# Staff Report

**SUBJECT:** Consideration of Parking and Public Improvements Commission Recommendation to Approve an Encroachment Permit Appeal to Allow Raised Planters in the Public Right-of-Way to Remain at 301 28<sup>th</sup> Street.

**SUBJECT:** Consideration of an Encroachment Permit Appeal to Allow Raised Planters in the Public Right-of-Way to Remain – 301 28<sup>th</sup> Street

# EXHIBIT F - WALLS HIGHER THAN 12"

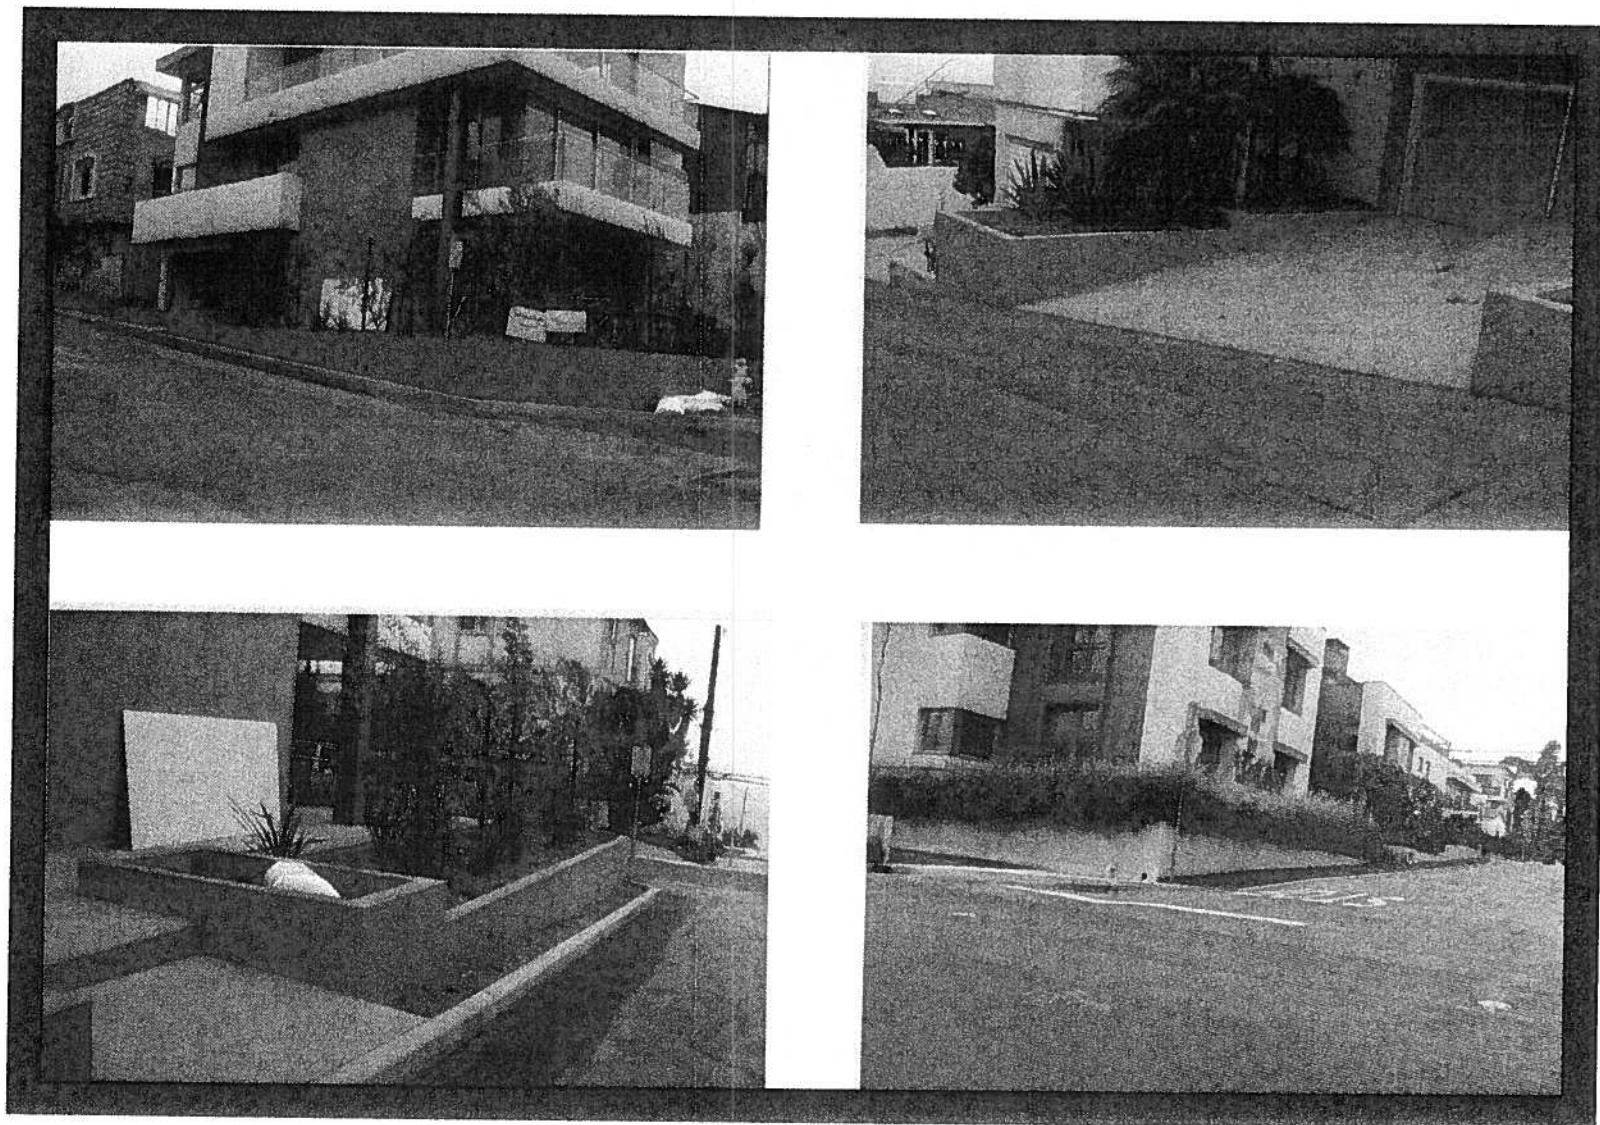
The City, in contending that the walls are too high, claims that the walls should not be more than 12" above the height of the curb. Apparently, the City is relying on the designations on the plans, again beginning with the upper east wall, of "1'-0" MAX", "11 5/8 MAX." and "1'- 0", respectively. These designations, at the very least, are inconsistent with the plan drawings and the elevations and are a meaningless limitation with respect to the curb height. As shown on the plans, these MAX dimensions are not drawn to the curb, but instead are clearly drawn to an unspecified grade level above the curb. See a blow-up of these "MAX" plan designations attached as Exhibit H. If the City intended the walls to have a height of no more than 12" above the curb height, the City should have put this on the plans.

The contractor was correct in building the walls according to the plan drawings and the designated elevation levels. There was no way to build the walls according to the "MAX." designations because this height depends upon an unspecified grade level. The City is attempting to re-write history if it claims that the walls were not built according to the plans because the height of the walls exceed a height of 12" above the height of the curb.

# EXHIBIT G - DECEMBER 15, 2010 APPROVED PLANS

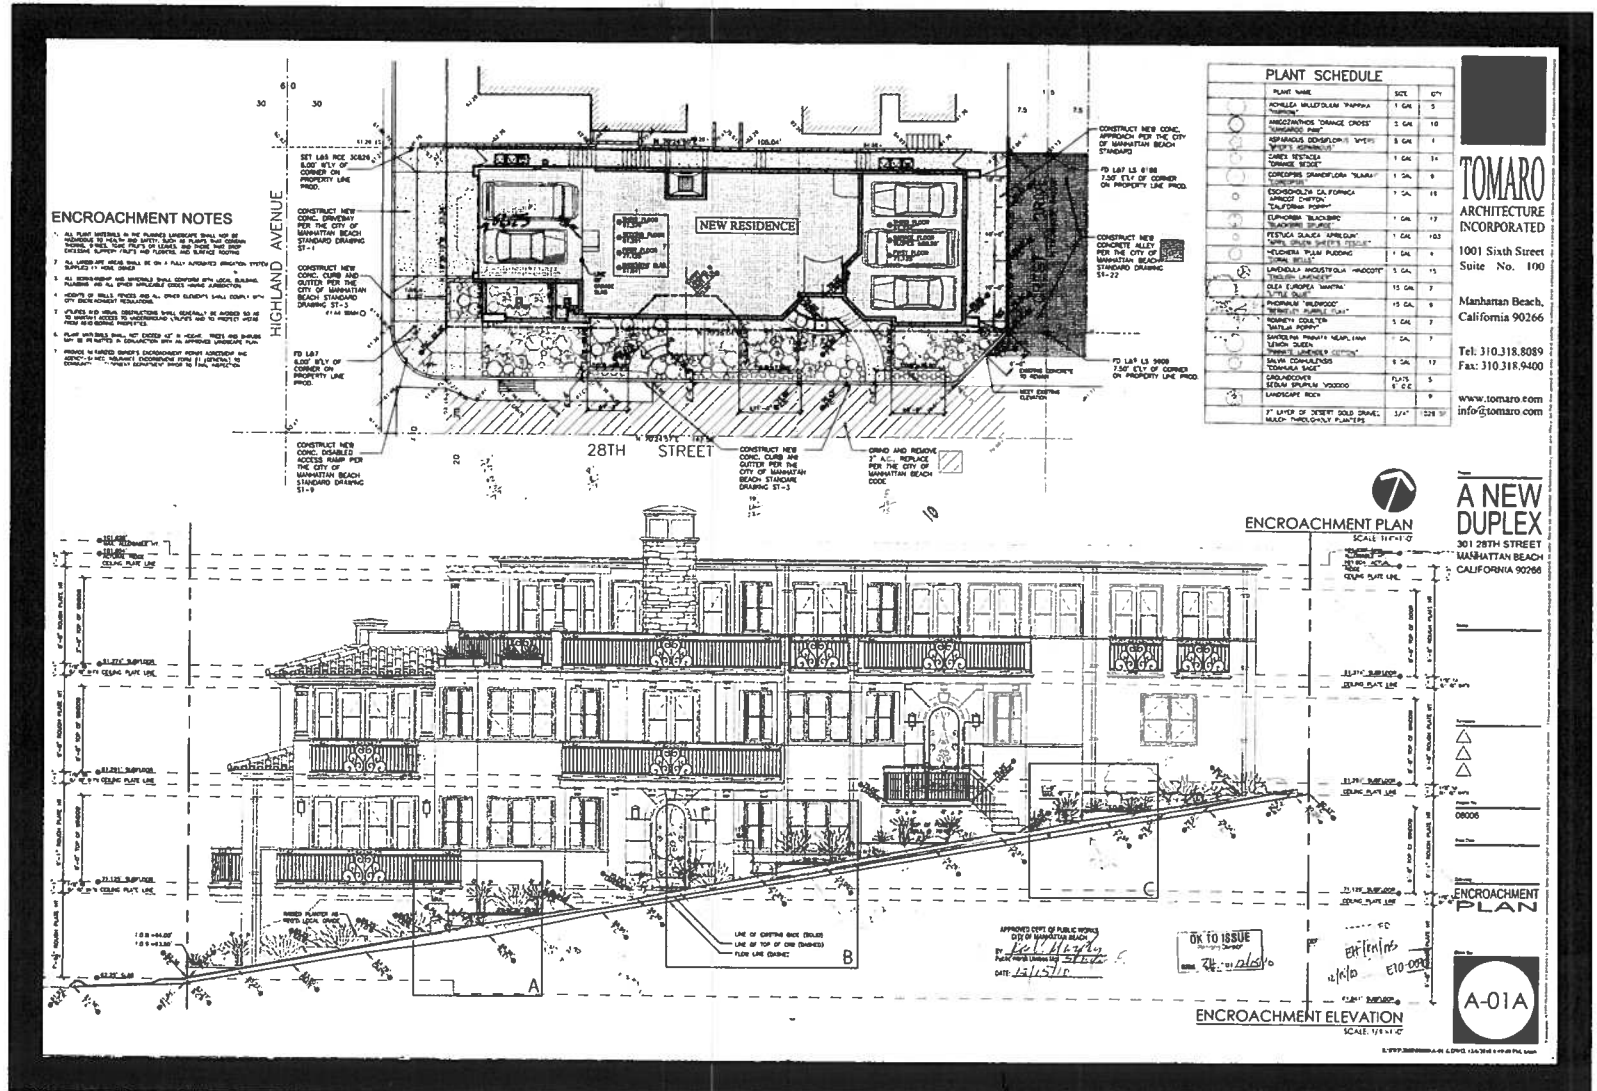
Contrary to the position taken by the City, the landscaping and the walls were built according to the Plans approved by the City on December 15, 2010. These approved plans are attached as Exhibit G. The present landscaping is the same as shown in the Plans except for a lower west wall with a height of 12" above the curb height which was added after planning indicated that additional 12" walls could be added. The other wall heights are consistent with the Plan drawings showing the walls relative to the building structure and the plan elevations. The maximum heights of the walls relative to the top of the curb beginning with the upper east wall are 20", 20 ½ "and 19", respectively. At the time the walls were constructed, there was no curb, but the height of the curb is irrelevant according to the approved plans.
